3 Volt Intel StrataFlash[®] Memory

28F128J3, 28F640J3, 28F320J3

Specification Update

Order Number: 298130-015

Figure 1. AC Waveform for Standard Word/Byte Read Operations

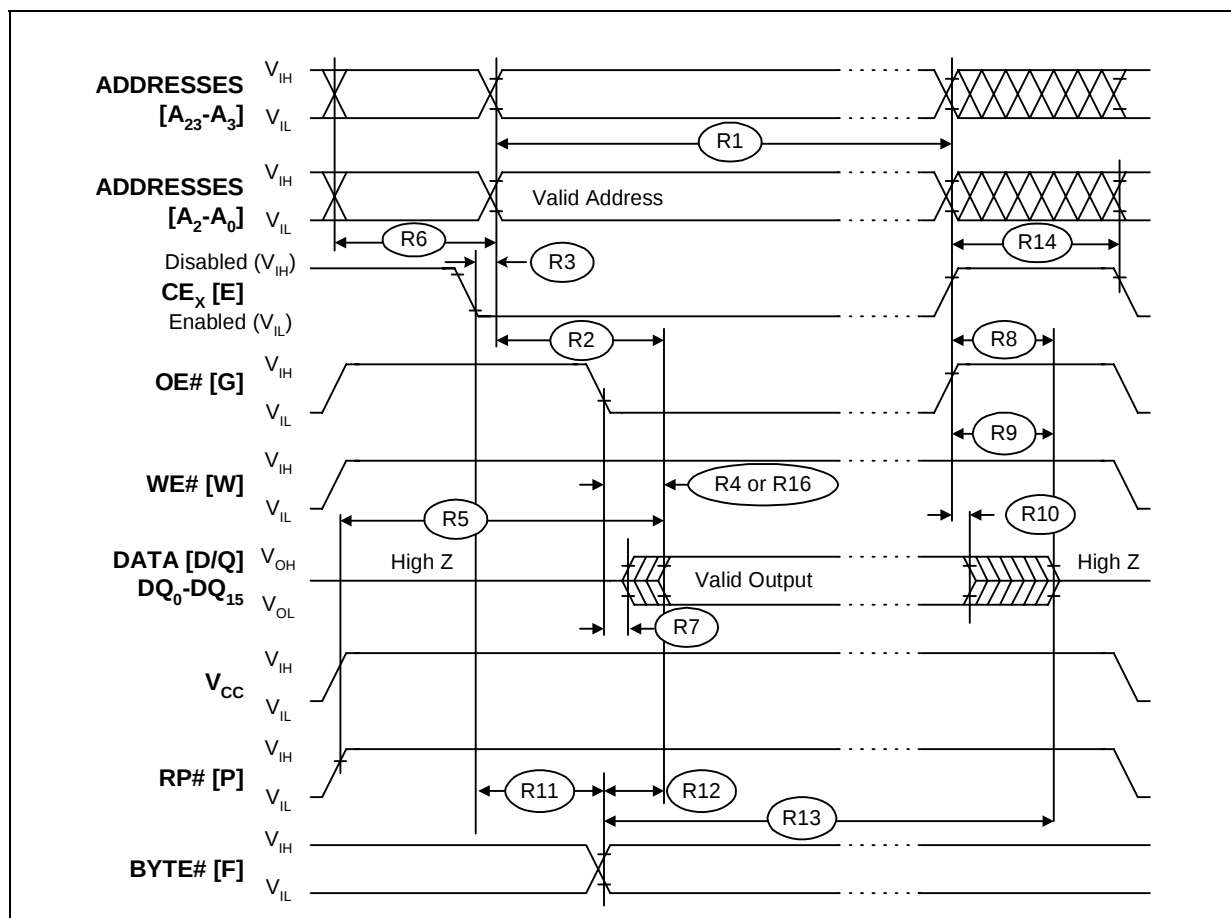
Problem: Devices need the parameter t_{ELQX} = 150 ns minimum. CE low to output in low Z (t_{ELQX}) is designated as R6 in Figure 1, in this Specification Update revision.

Problem: Devices need the parameter t_{ELAV} = 500 ns maximum. Chip Enable to Address Valid (t_{ELAV}) is designated as R3 in Figure 1, in this Specification Update revision.
